ADDENDUM NO. 1

Invitation to Bid (ITB) No. 12-0218

Lake County Administration Building Public Lighting Upgrades / EECBG

Watt Stopper/Legrand 800-879-8585			
Title Two Circuit Or Two Load Sensor Control			
Scale None	Drawing# 57-005	Date 12/15/05	Rev. 3

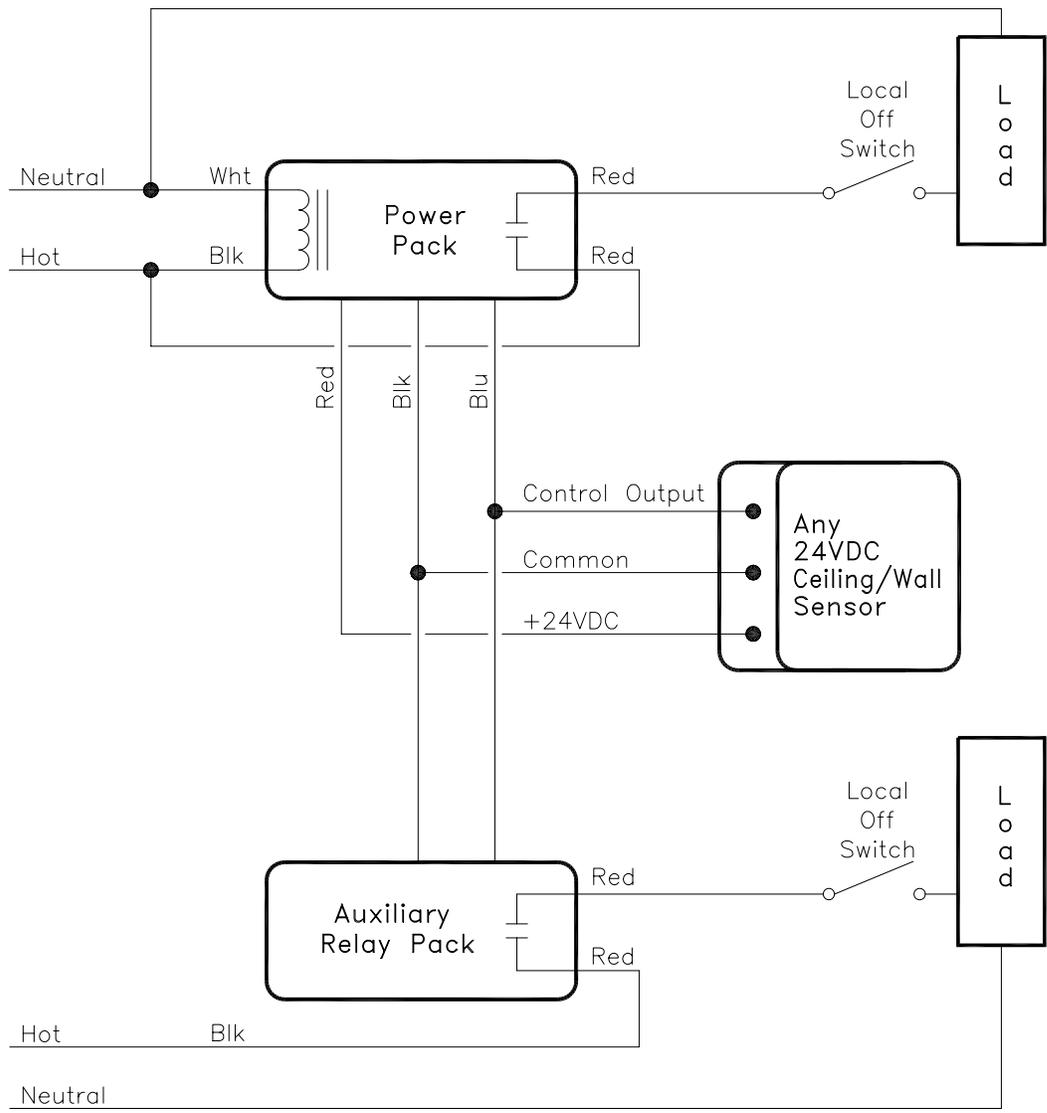
Question 8: Is there a wiring diagram available for the sensors?

Answer 8: Refer to attached wiring diagram 57-005 and 58-007.
